EMPLOYEE OUTDOOR MEAL BREAK AREA SUB PLAN

Moorebank Precinct East Stage 2

Report No SSS2-QPMS-EN-APP-00038

**Moorebank Precinct East – Stage 2 (condition B140, SSI 7628)
Urban Design and Landscape Plan**

WAREHOUSE 3 & 4 PRECINCT LANDSCAPE SECTION 3

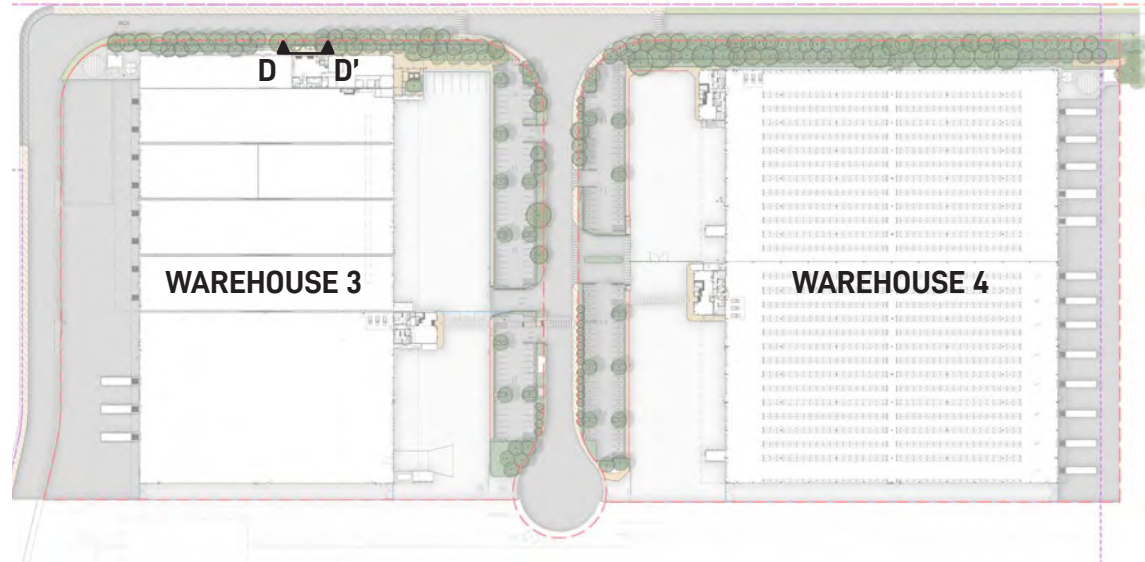
Warehouse 3 & 4 Precinct Landscape Section 3 - Dwg # W3W4-GNK-LN-DWG-2303 dated 13.02.20 — show and label features of the EOMBA listed in Section 2.3.2 including a pergola and fencing with climbers, permeable pavers, furniture and other landscaping including a couple of large feature trees. However, some details are inconsistent with features specified in Section 2.3.2 such as fencing and feature trees, while planter boxes are not clearly shown.

WAREHOUSE 3 & 4 PRECINCT LANDSCAPE SECTION 4

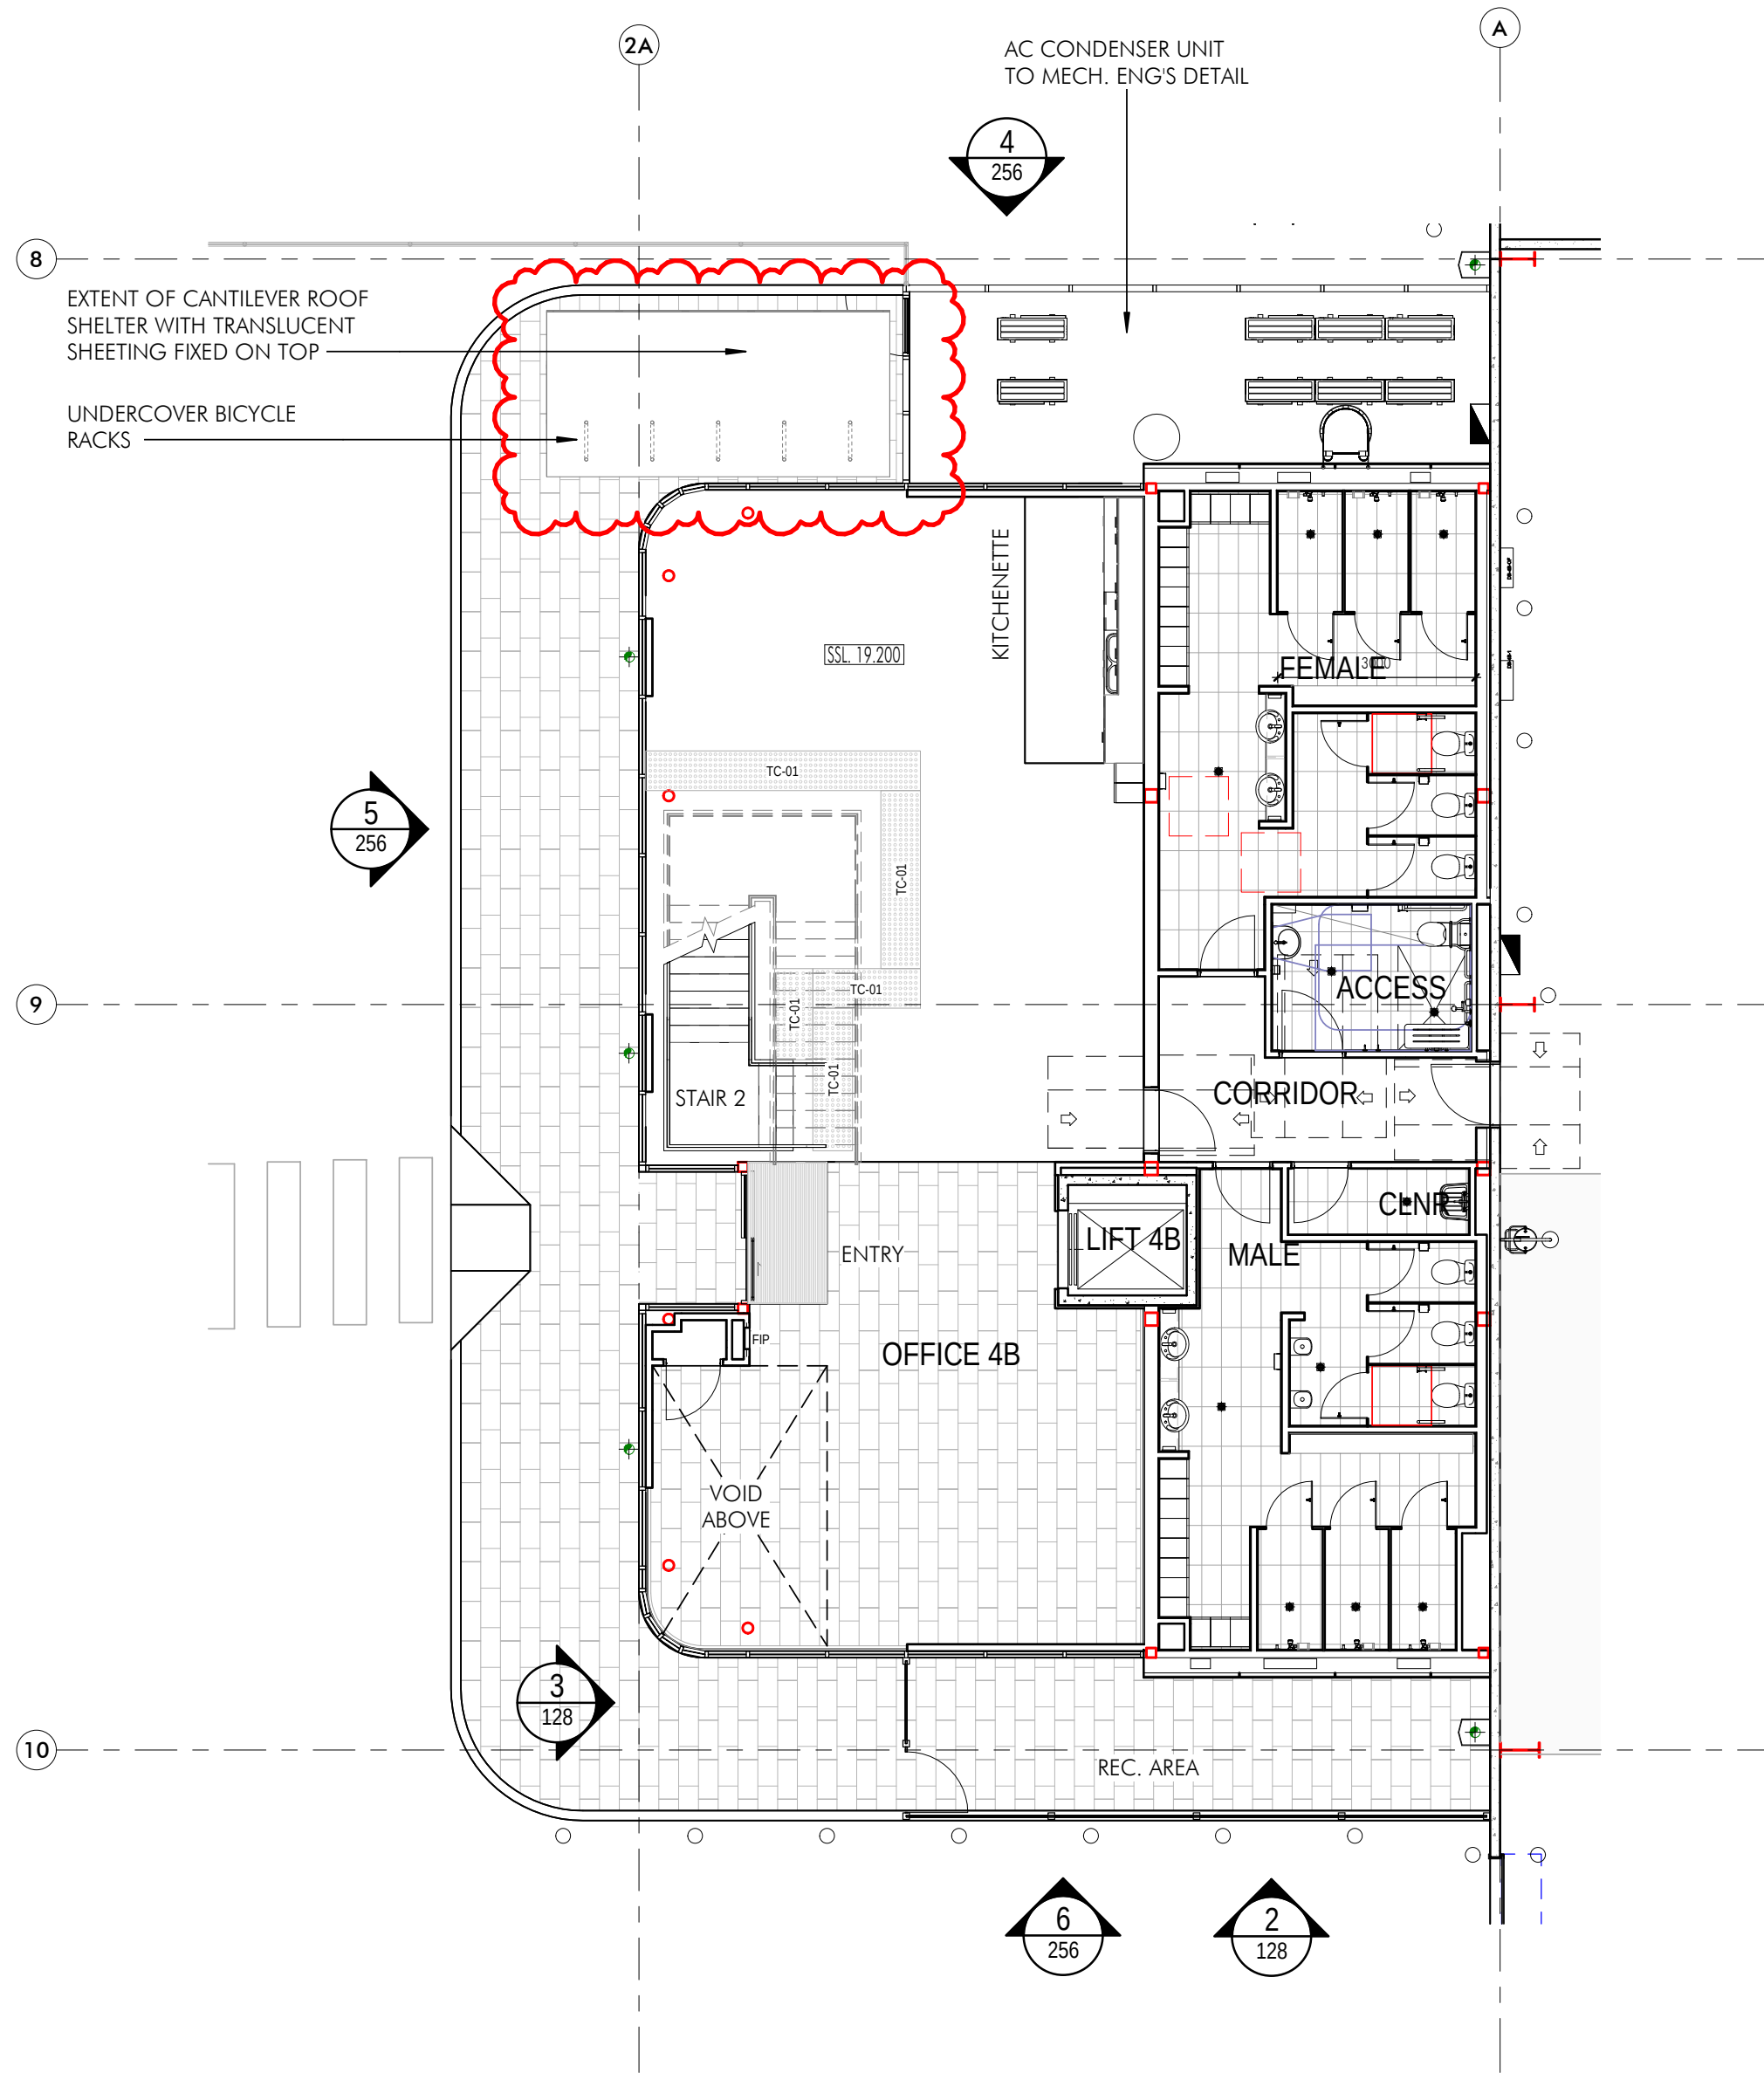
Warehouse 3 & 4 Precinct Landscape Section – Dwg# W3W4-GNK-LN-DWG-2304 dated 13.02.20 - shows and labels EOMBA features listed in Section 2.3.2 including metal-slat screen with screen planting, translucent awning, furniture, permeable pavers. It is noted that screen planting may occurring in planter boxes to the eastern end of warehouse 3 (as shown in section DD).
